11-2009
6349DWFE
18V 1/2" DRIVER DRILL KIT

SERVICE CHANGES**1. Changes on Gear Assy and Speed Change Lever Assy**

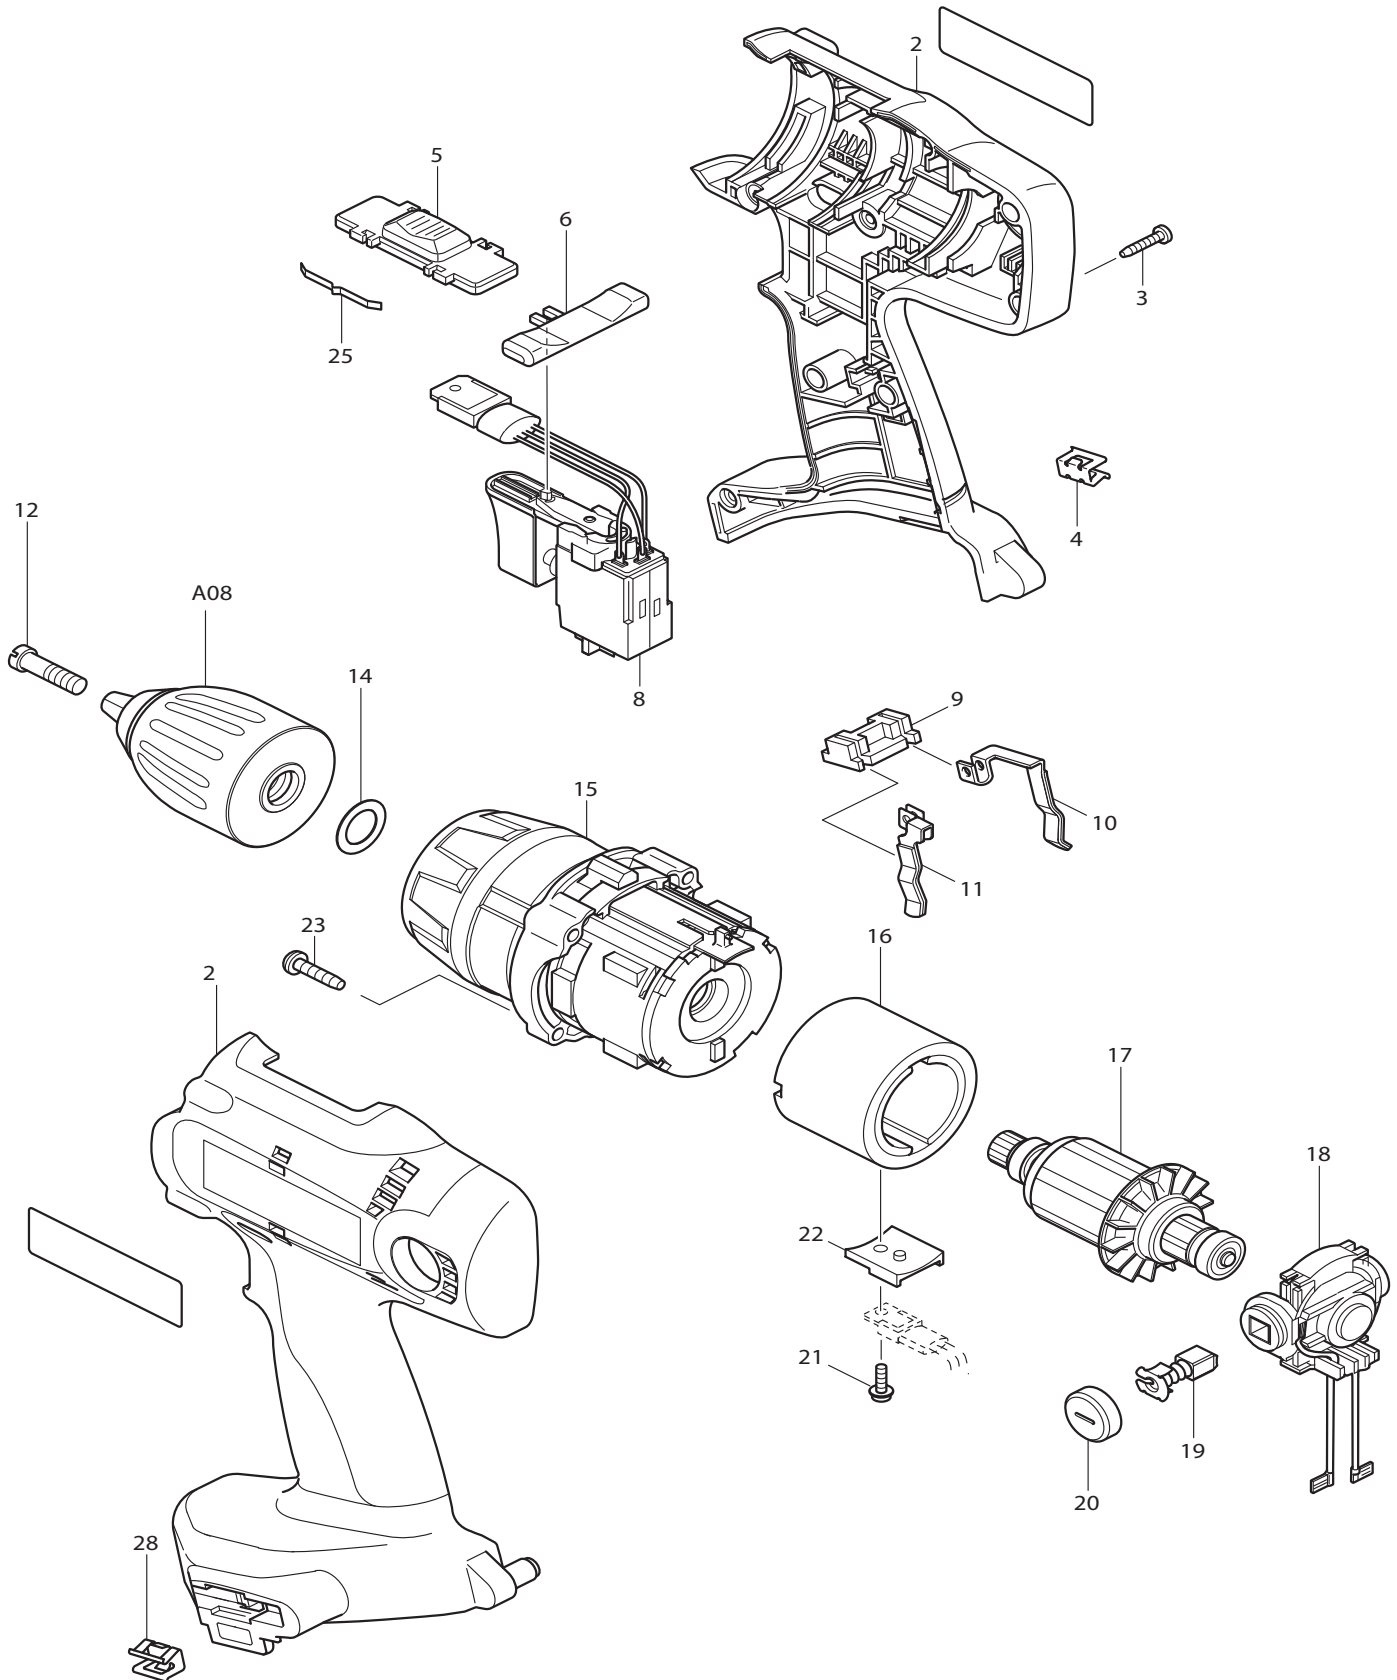
Item No.	Description	Type 1	Type 2	Type 3
5	Speed Change Lever Assy	125261-2		125434-7
15	Gear Assy	125284-0 (Lot No. in White)	125340-6 (Lot No. in Silver)	125432-1 (Lot No. 07-25~)
15	Speed Change Ring (Comp.of Item No.15)	418763-8		419558-2
15	Change Lever (Comp.of Item No.15)	-----	419557-4	450385-8
15	Pin (Comp.of Item No.15)	268088-8 (PIN 1.2 = 12mm)		268199-9 (PIN 1.4 = 1.35mm)

Above parts are completely interchangeable as a set.
